3 Volt Intel[®] Advanced+ Boot Block Flash Memory

28F800C3, 28F160C3, 28F320C3, 28F640C3

Specification Update

Order Number: 297938-014

2. 28F320C3xC Reset Failure

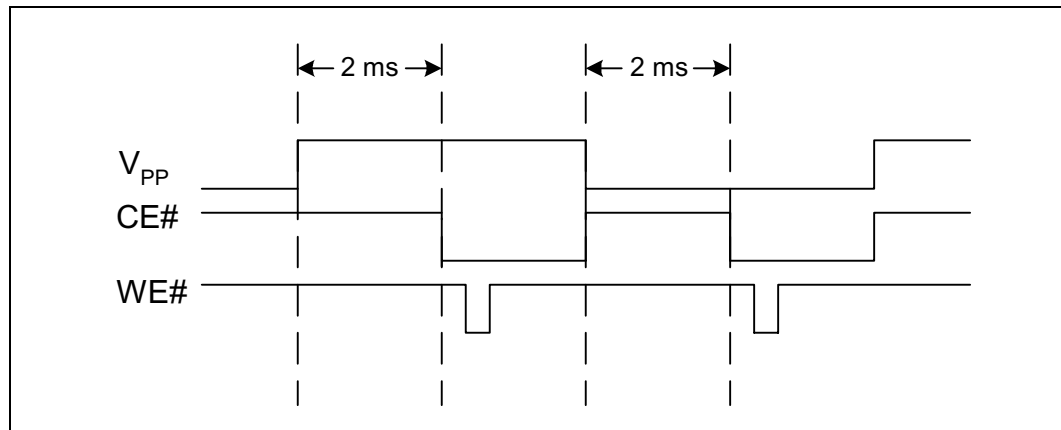
Problem: The 0.18 μ m 28F320C3xC devices can unintentionally reset under certain conditions where V_{PP} toggles.

Implication: When the reset occurs, any command being executed is interrupted and the flash switches to read array mode.

- 1) Tie V_{PP} to V_{CC} ;
- 2) If the third and fourth digits on the top side FPO mark (third line) is equal or greater than “23”, then V_{CC} may be set from 2.7v to 3.3v. V_{CC} must not exceed 3.3v
- 3) Set V_{PP} to a static high or static low level as shown here; and

4) Wait 2 ms after a V_{PP} transition to access the flash device, as shown here.

Figure 1. Workaround Placement

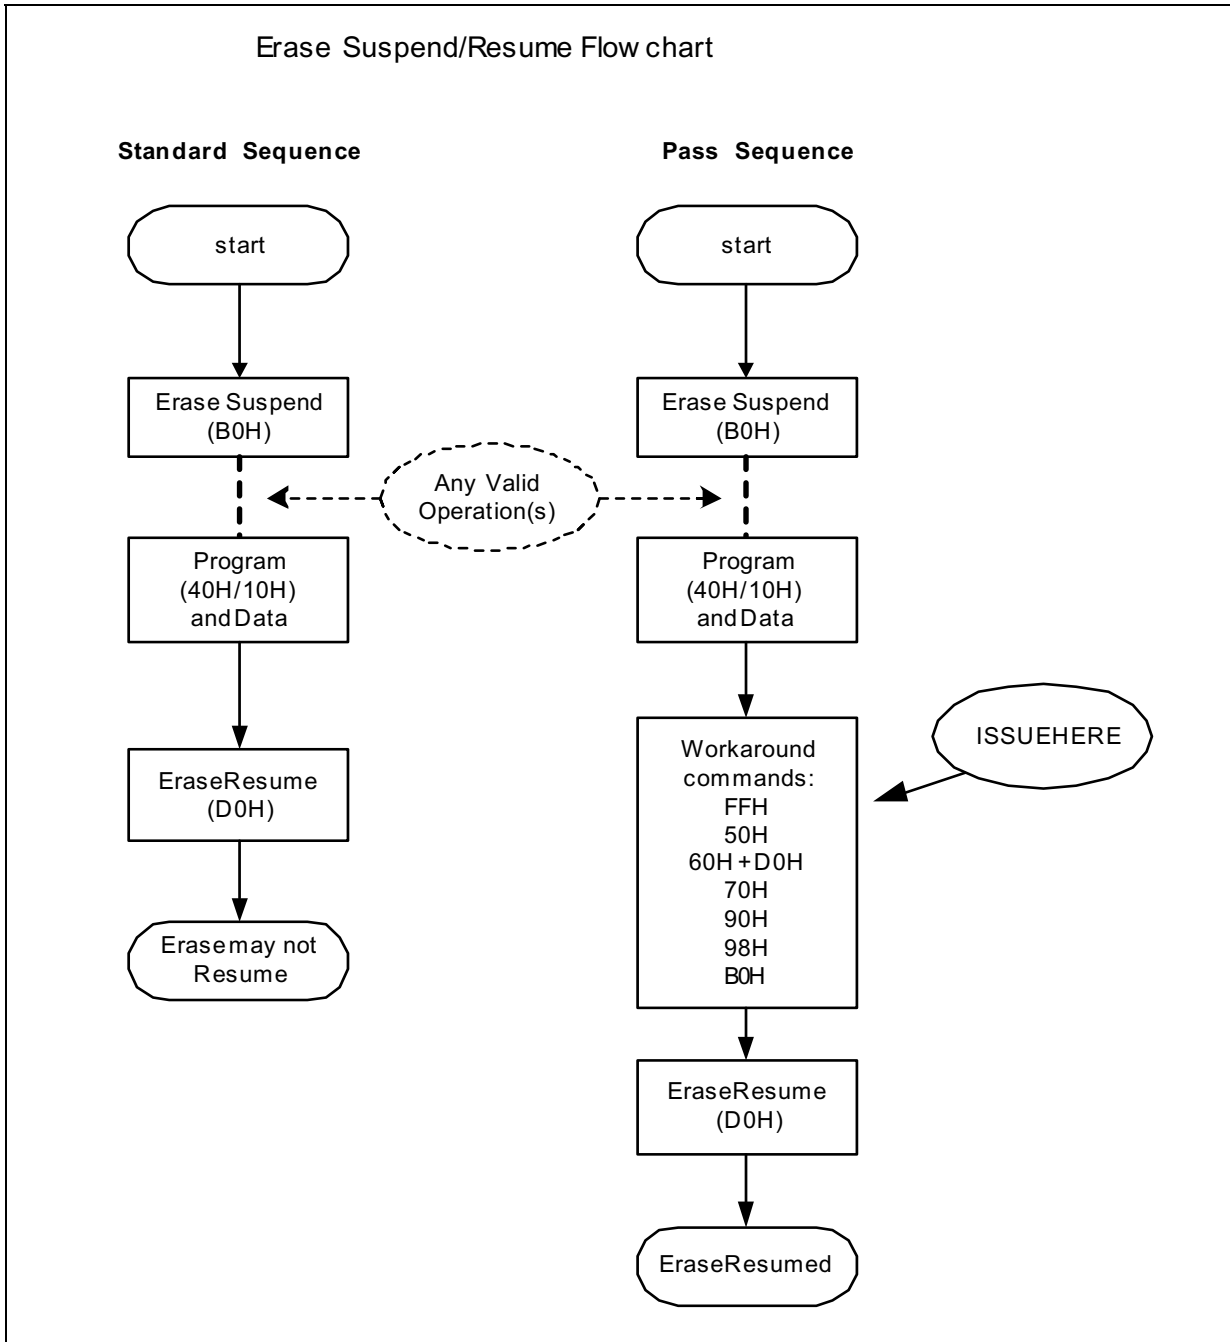
Problem: On the 0.18µm 28F160C3xC devices, a design anomaly was discovered. During an Erase-Suspend operation, if the Program (40H/10H) sequence is executed, under limited conditions the proceeding Erase Resume command (D0H) may not actually resume the device. No customers have reported failures in product applications. Customers who use any version of FDI (Intel Flash Data Integrator) software will not see this issue. If the Read Array command is issued prior to the Erase Resume command, users will not see the issue (typical in XIP applications).

Implication: The Resume Command (D0H) may be ignored by the device and will not correctly resume. The device will appear to remain in suspend (via status register). After a reset of the flash device the status register will clear. This failure has been recreated in a lab environment only.

1. If FDI (Intel Flash Data Integrator) software is used, users will not see the issue.
2. During an Erase-Suspend (B0H), user must issue any of the following commands after issuing the Program (40H/10H) and data sequence but before issuing the Erase-Resume (D0H) command.

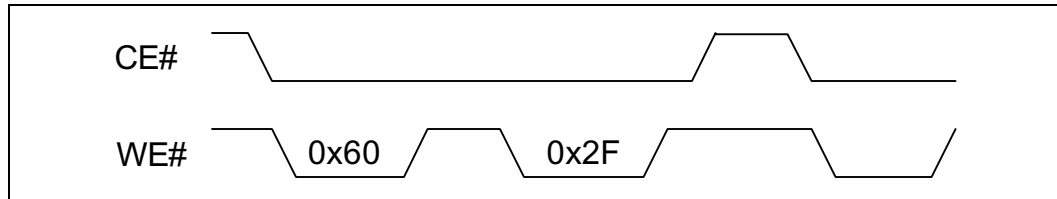
Problem: On the 16Mb and 64Mb 0.18µm devices, if CE# is deasserted after any block lock operation and before the next write sequence, the part may perform the same operation on additional blocks. (See waveform below.)

Implication: When CE# is deasserted after performing a block lock operation to a specific block and prior to the next write sequence, other blocks may perform the same operation.

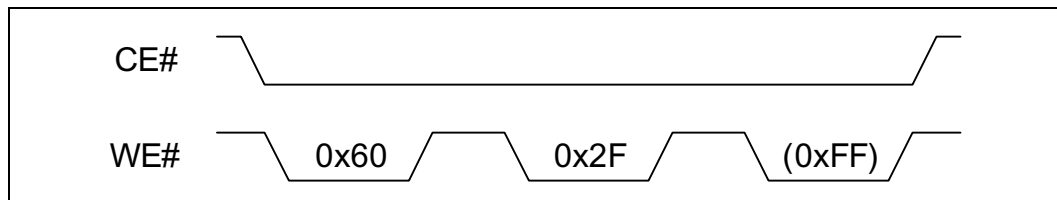
Immediately after performing a block lock, unlock, or lock-down operation, perform a valid write sequence before chip enable (CE#) is deasserted.

- 1) Assert CE# and toggle WE# to write the block lock setup command (0x60).
- 2) Toggle WE# a second time to write the confirm command (lock = 0x01; unlock = 0xD0; lock-down = 0x2F).
- 3) Toggle WE# a third time (ex: 0xFF- Read Array) before CE# is deasserted. (See waveform below.) Any other valid write sequence will also work (i.e., 0x90 - Read Configuration, 0x40 - Program, 0x20 - Erase).
